REVIEW OF DETERMINATION ASSESSMENT REPORT

| Application Number: | REV2021/0020 |

| Land to be developed (Address): | Lot 1 DP 827733, 316 Hudson Parade CLAREVILLE NSW 2107 |
| Proposed Development: | Review of Determination of Application DA2020/1591 for alterations and additions to a dwelling house and garage |

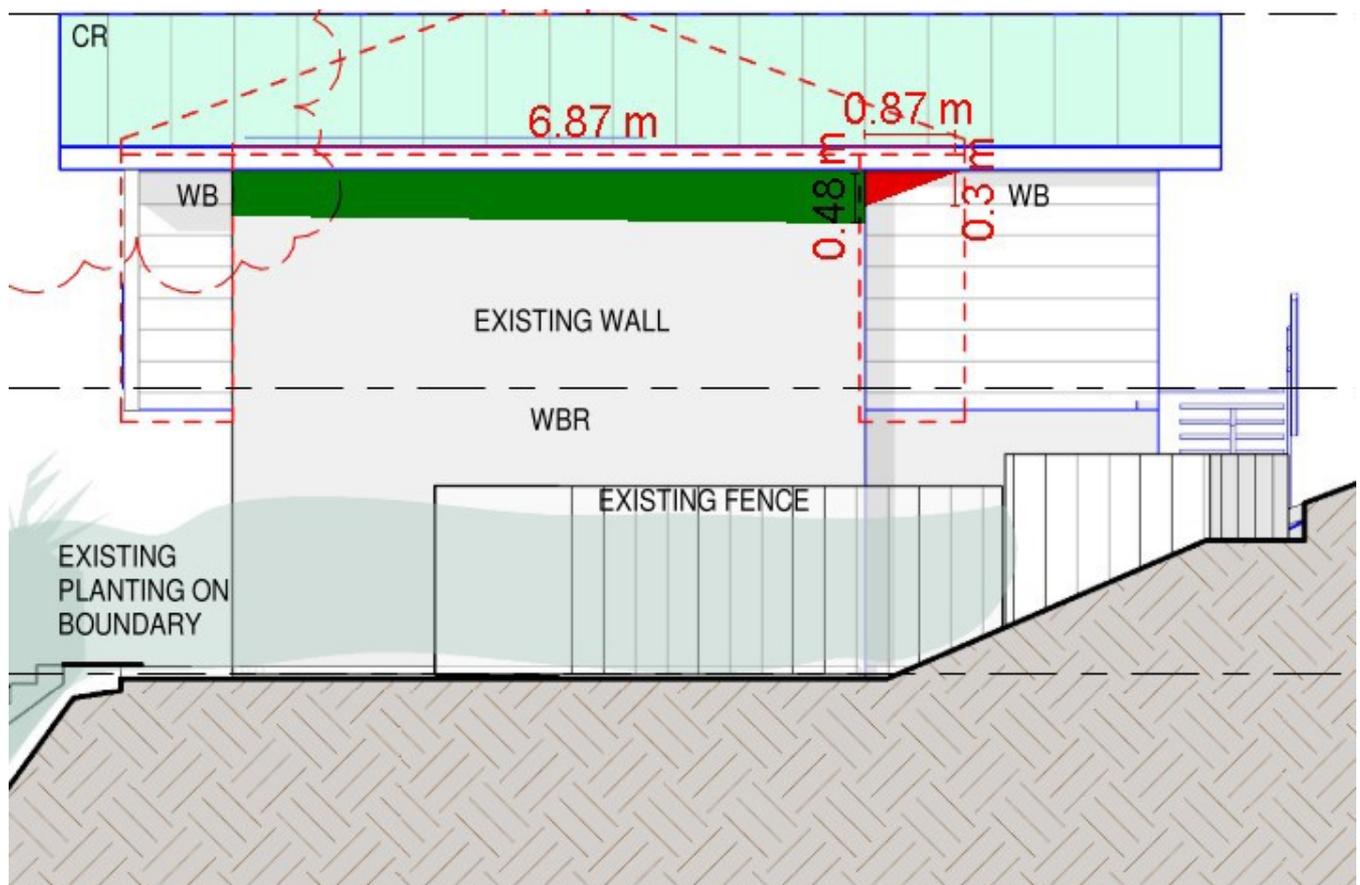
The proposal includes a building envelope breach at the southern elevation of the detached gym/studio. The proposed breach is limited to a maximum of 300mm for a length of 870mm (red) as indicated on the below plan. The existing southern wall and associated breach (green) remains unchanged.

The proposed non-compliance is minor in extent and will not result in excessive bulk or scale. The overall bulk of the studio/gym is minimised as a result of the amended plans that increase the balcony side setback and reduce the western eave overhang.
